Integrated Device Technology, Inc.
6024 Silver Creek Valley Road, San Jose, CA - 95138

PRODUCT/PROCESS CHANGE NOTICE (PCN)

PCN #: TB1912-02	DATE December 20, 2019	MEANS OF DISTINGUISHING CHANGED DEVICES:
Product Affected: 3mm X 3mm VFQFN 4mm X 4mm VFQFN (Refer to attachment for affected part#)		<input type="checkbox"/> Product Mark
Date Effective: March 20, 2020		<input type="checkbox"/> Back Mark
		<input type="checkbox"/> Date Code
		<input checked="" type="checkbox"/> Other

ATTACHMENT I - PCN #: TB1912-02

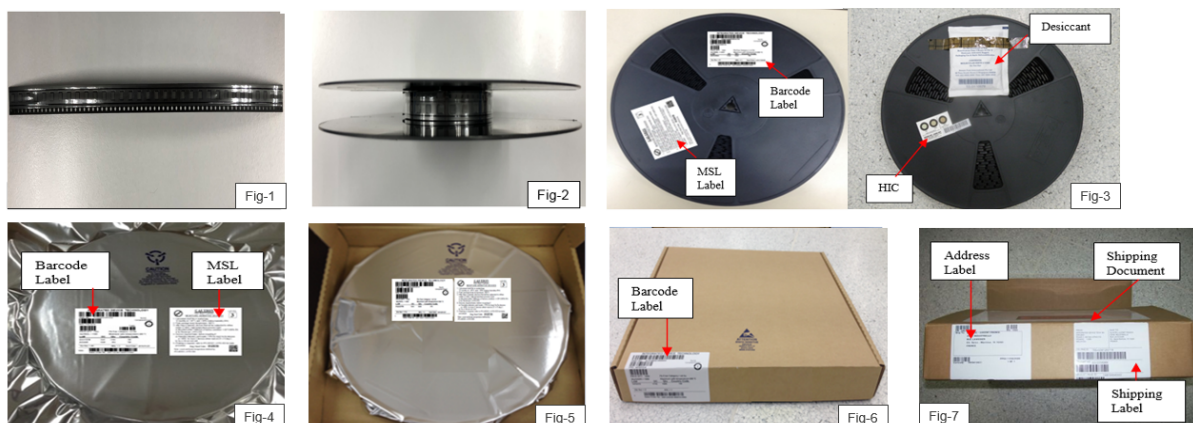
Future Shipment in Cut Tape Packing for MSL 1 Product

1. Count and cut the parts in carrier tape as per order qty (Fig-1).
Note: Without Leader & Trailer empty pockets.
2. Roll the part onto plastic reel and tape with conductive tape at both end (Fig-2 & 3).
**** Note :** Pass IDT Standard 6 fts drop test (Base on drop test result with NLG 16 (QFN 3x3 mm) and NLG 24 (QFN 4x4 mm))
3. Pack with Shielding bag (Fig-4).
4. Pack with pizza box (Fig-5).
5. Over-pack the pizza box with Outer carton (Fig-6).

Future Shipment in Cut Tape Packing for MSL 2/3/4 Product

1. Count and cut the parts in carrier tape as per order qty (Fig-1).
Note: Without Leader & Trailer empty pockets.
2. Roll the part onto plastic reel and tape with conductive tape at both end (Fig-2 & 3).
**** Note :** Pass IDT Standard 6 fts drop test (Base on drop test result with NLG 16 (QFN 3x3 mm) and NLG 24 (QFN 4x4 mm))
3. Pack with HIC & Desiccant
4. Pack with MBB bag (Fig-4).
5. Pack with pizza box (Fig-5&6).
6. Over-pack the pizza box with Outer carton (Fig-7).
